Official Recall Notification U.S. Federal Boat Safety Act Start In-Gear Protection - Tiller Handle Kits

Models Affected

Models Covered	Model Year
115 HP FourStroke	2003
75-115 HP FourStroke	2004
75-115 HP FourStroke	2005 through April 1, 2008

Tiller Handle Kit Part Numbers:	
816366A32	816366A38
816366A35 (superseded to A46)	816366A46
816366A36 (superseded to A38)	816366A50
816366A37

Shift lever with white dot

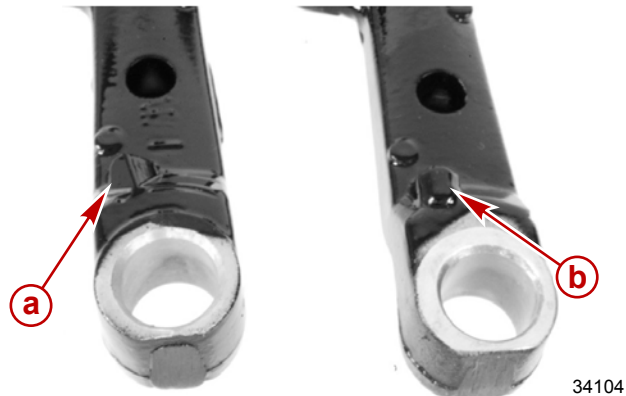
Mercury Marine has updated the kits in Mercury stock. Any new kits produced after April 1, 2008 will have the updated components. A white dot is located on the underside of the new shift lever. Kits in the field, or kits previously installed on an engine, may be inspected for a white dot on the underside of the shift lever.

a - New style with pointed switch activator

b - Original style with flat at the top of the switch activator

Shift switch with white dot

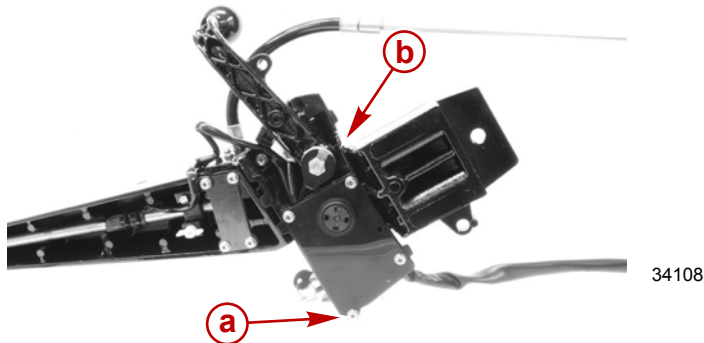
The neutral switch will also have a white dot by the mounting holes, although it may not be visible without removal. The part number 8M0033667 will be on the switch harness.

Reinstall the components in reverse order using the new shift lever part number 8M0033001 and the new shift switch part number 8M0033667. Use Loctite 271 Threadlocker on the 8 mm lever mounting bolt threads and tighten to the specified torque. Also use Loctite 271 Threadlocker on the shift ball mounting stud threads, both for the lever and ball ends, and hand-tighten.

Lever bolt and cover with screws

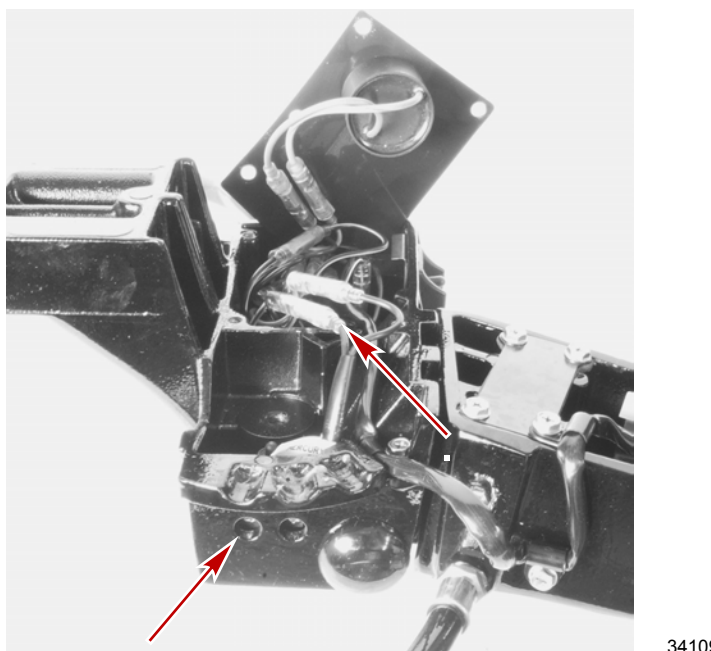
5. Remove the 8 mm mounting bolt, retention tab washer, and the three washers on the underside of the shift lever. During the removal process, the detent ball and spring will be under compression. Remove the lever slowly and capture the ball and spring. Remove the lever and retain the detent, spring, and mounting components.

- a** - Mounting cover mounting bolt (4)
- b** - 8 mm bolt
